February 26, 2015

ADDENDUM B

Saint James Catholic Church
Phase 1 Renovations and Additions
Kearney, Nebraska
RDG Project No. 2013.203.01, File 35.1

C6.1 ALUM JAMB
 1 1/2" = 1'-0"

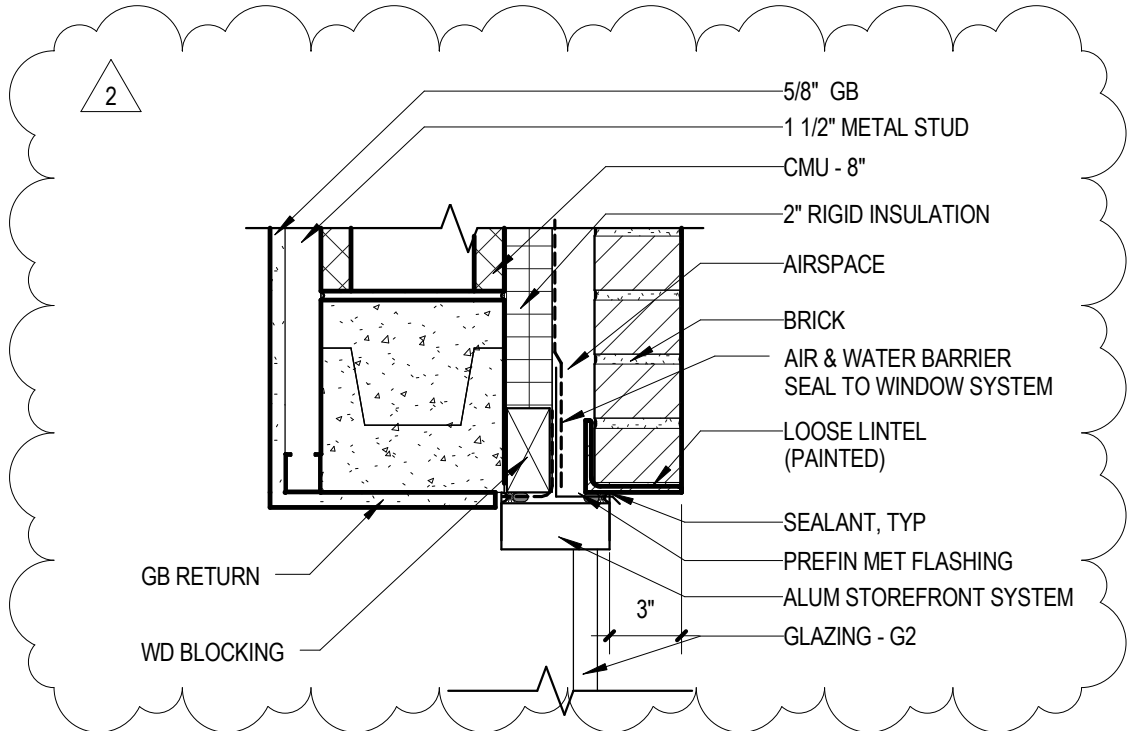
- A. Delete Details A3.1, A6.1, B3, C5.1, and C5.2.
- B. Detail B3: Revise per attached Supplemental Drawing SDA-07.
- C. Add Detail C6.1, Alum Jamb, per attached Supplemental Drawing SDA-14.
- D. Details E6 and D6: Revise per attached Supplemental Drawing SDA-15.
- E. Detail D5: Add hardwood sill @ window and note reading:

C3 DETAIL
 1 1/2" = 1'-0"

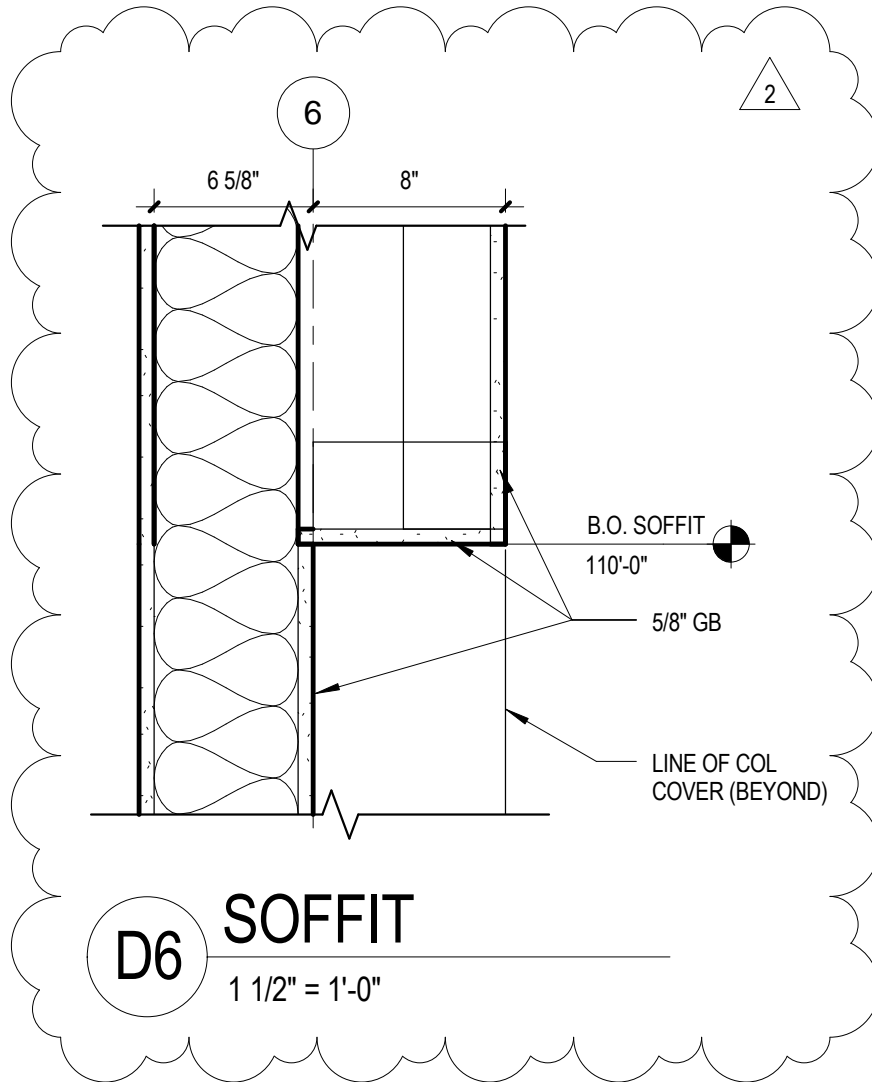
3/4" Hardwood sill w/ bullnose edge and 1/2" projection.
- F. Detail C3: Revise per attached Supplemental Drawing SDA-16.
- G. Details A5.2 and A6.2: Revise location of compressible fill to be under frame and change note reading "compressible fill" to read, ***"1" rigid insulation."***

D1 INTERIOR ELEVATION 123N
 1/4" = 1'-0"

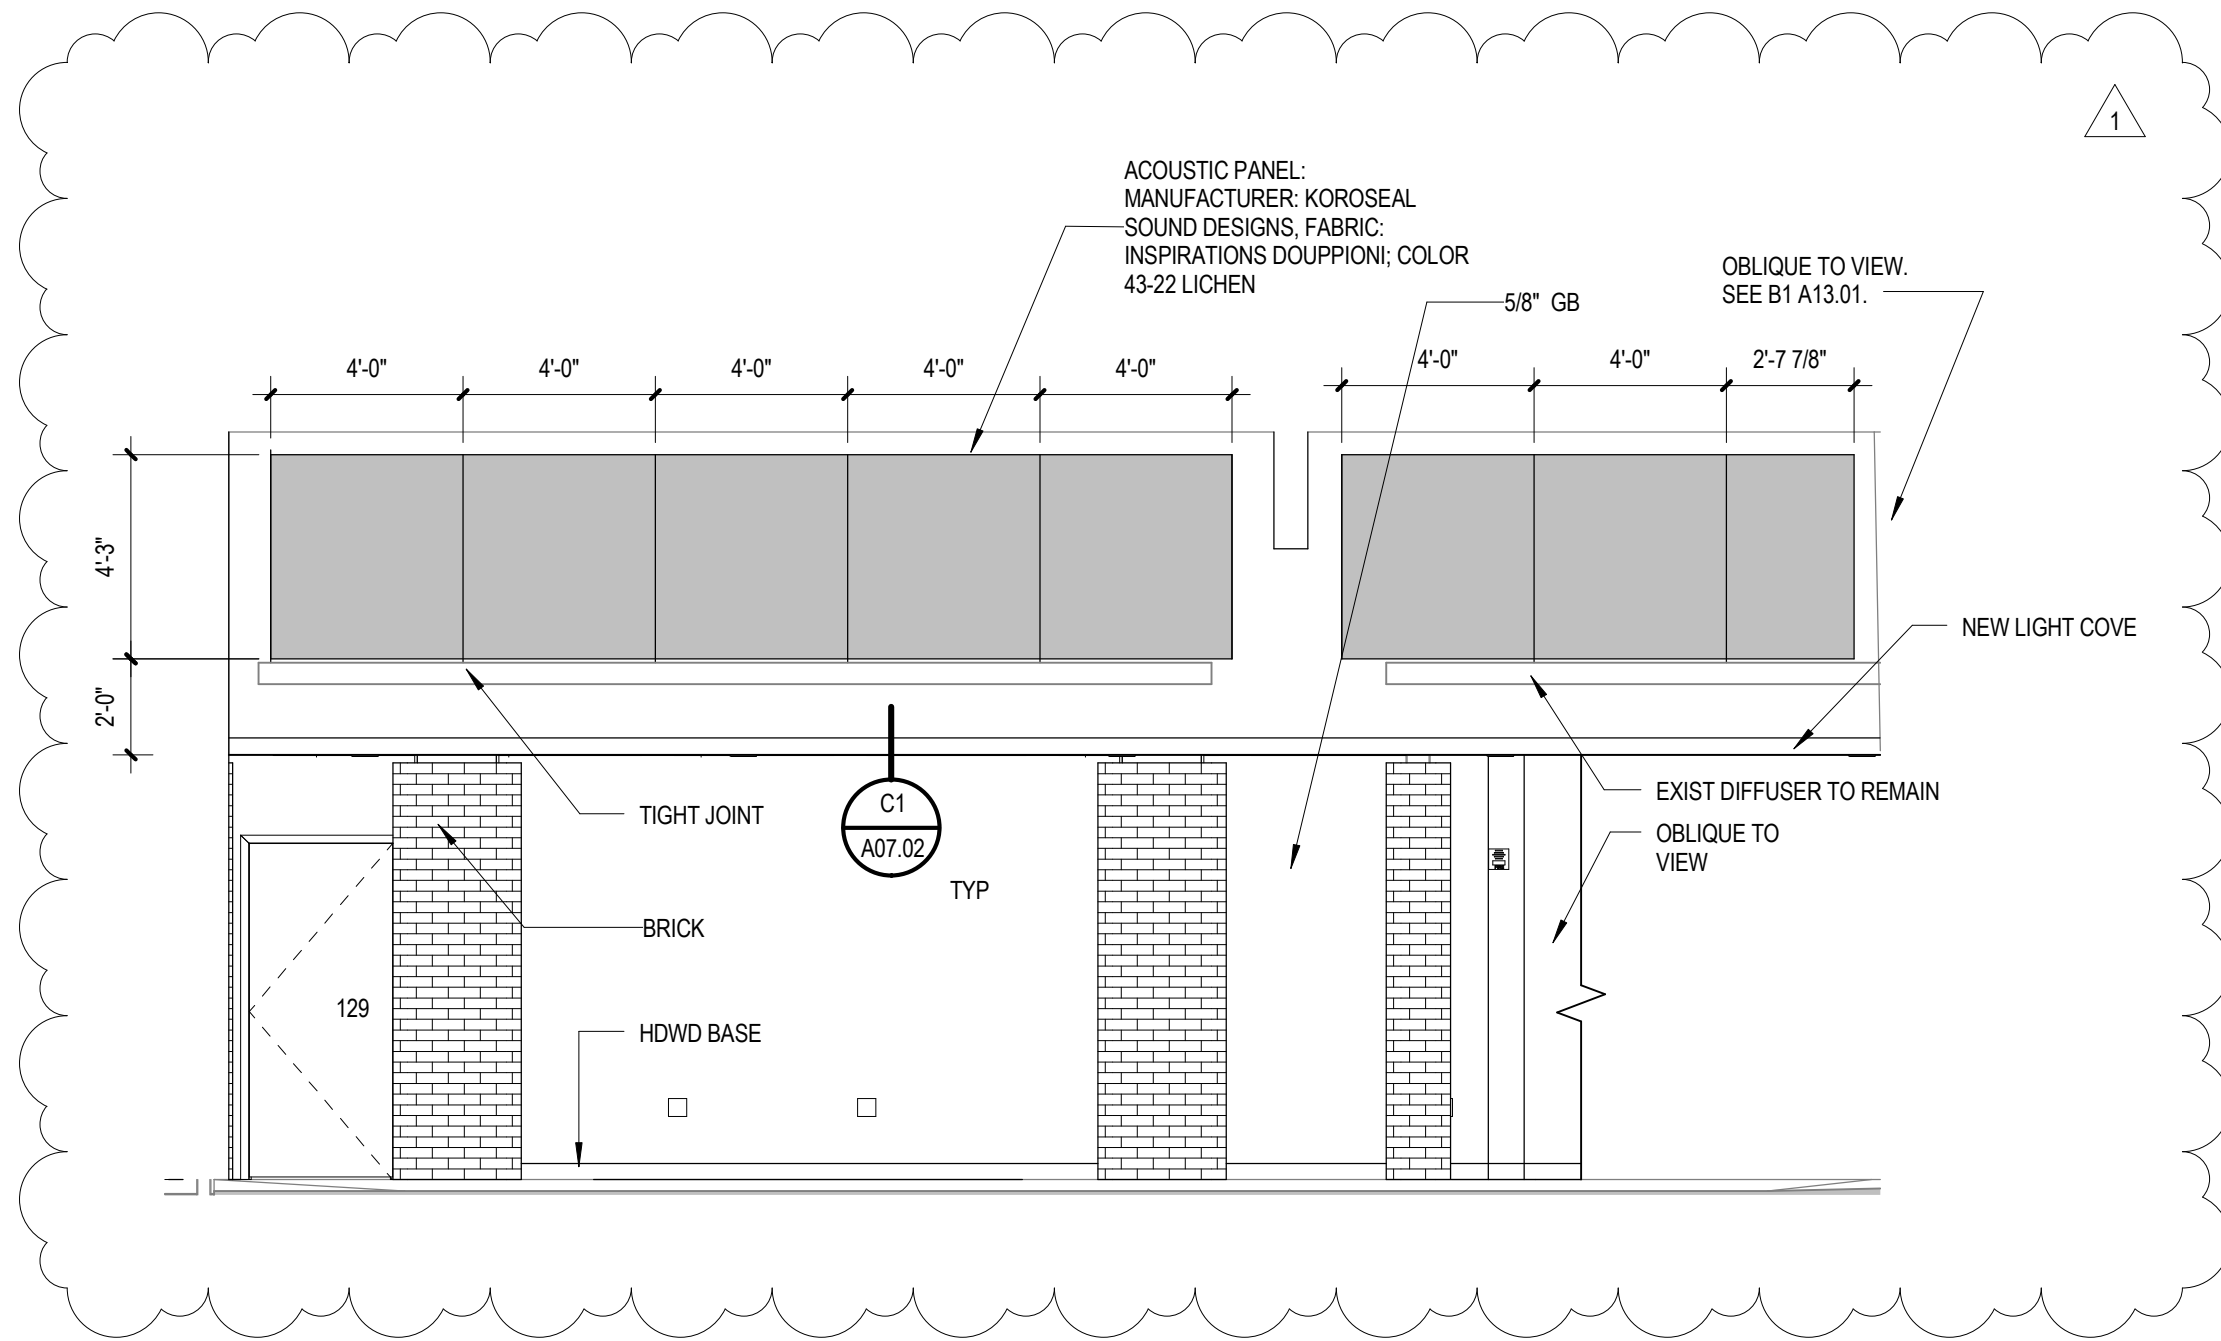
- A. Add Detail D6, Soffit, per attached Supplemental Drawing SDA-17.
- B. Elevations D1, D3, B1, and B4: Update elevations per attached Supplemental Drawings SDA-18 through SDA-21.
- C. Elevations A2.1 and A3.1:
 - 1. Delete the note “Plam top and backsplash” and replace with a note reading, **“Simulated stone top and backsplash.”**
 - 2. Delete the note “Plam valance” and replace with a note reading, **“Simulated stone valance.”**

SDA-22

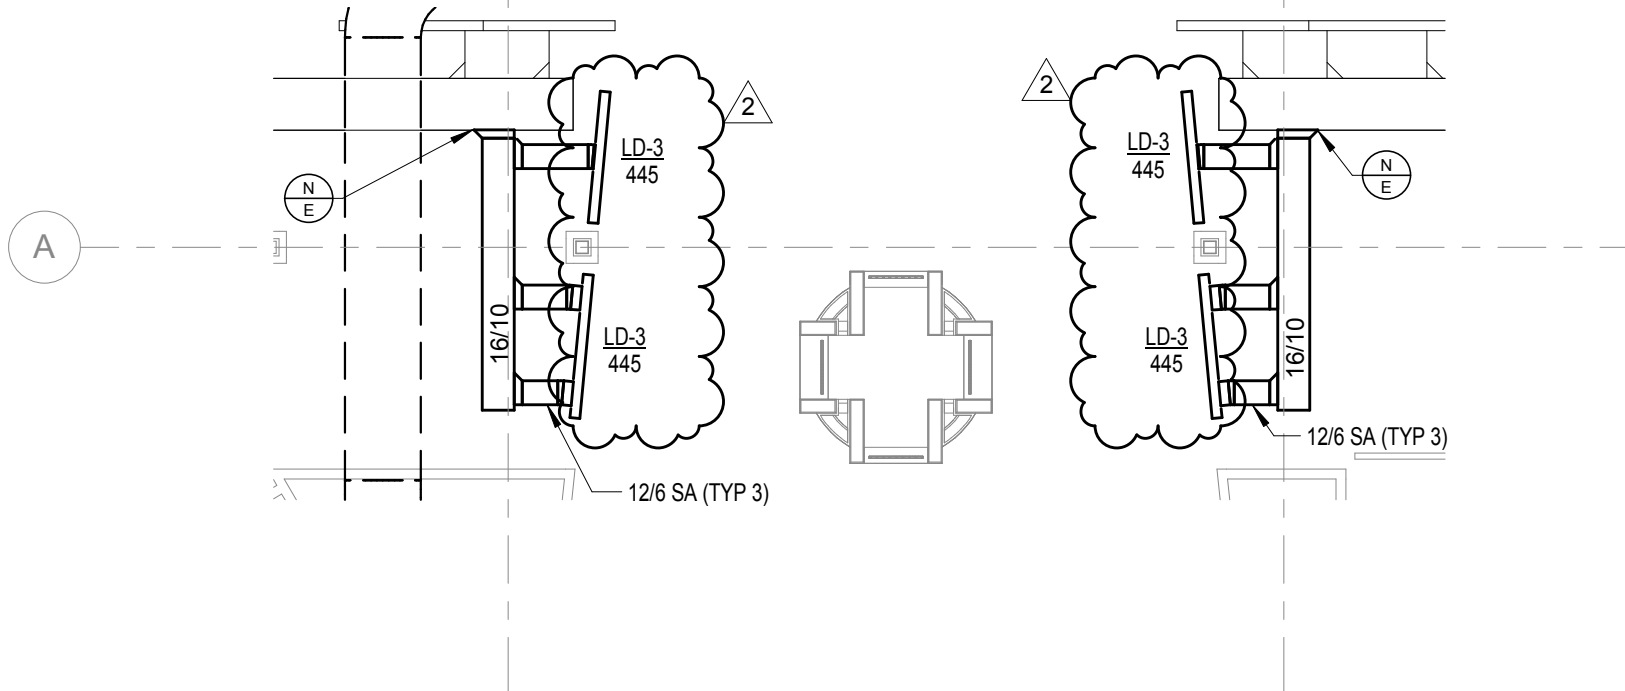
Sheet M02.01 – Floor Plan – HVAC: Provide new linear diffusers (LD-3) at entry of worship center. See attached Sketch Sheet SDM-04.

- 1 REBALANCE EXISTING LINEAR TO 895 CFM.
- 2 NOT USED.
- 3 PROVIDE (3) 6' LONG LINEAR GRILLES (LD-2). INSTALL LINEAR GRILLE VERTICALLY ALONG WALL STARTING AT FINISHED FLOOR.
- 4 PROVIDE (2) 108x10 RETURN AIR DUCTS UP IN WALL. TOP OF DUCT SHALL BE OPEN IN WALL. EXTEND DUCT DOWN THROUGH FLOOR 24" BELOW BOTTOM OF SLAB. TAP NEW 14"Ø DUCTS FROM EXISTING DUCT TO NEW DUCT.

SKETCH
SDE-04

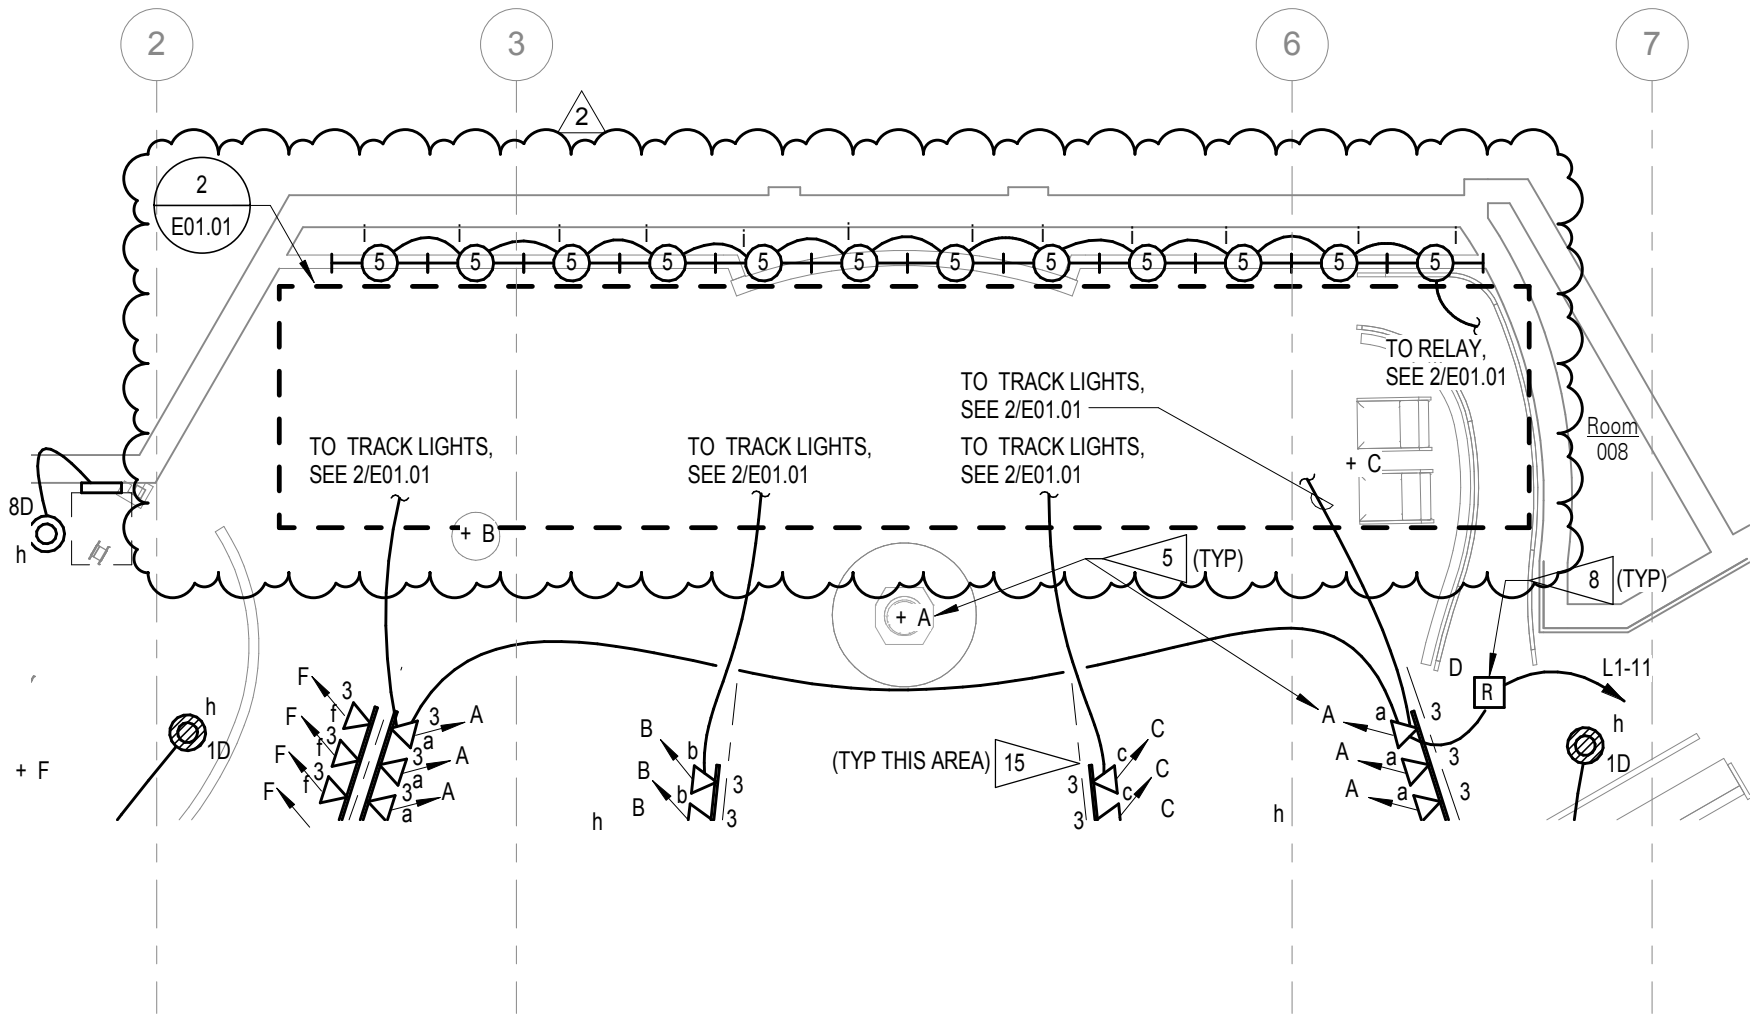
Sheet E01.01 – Floor Plan – Lighting: Revise luminaire Type 4D locations per attached Sketch Sheets SDE-04, SDE-05, and SDE-06.
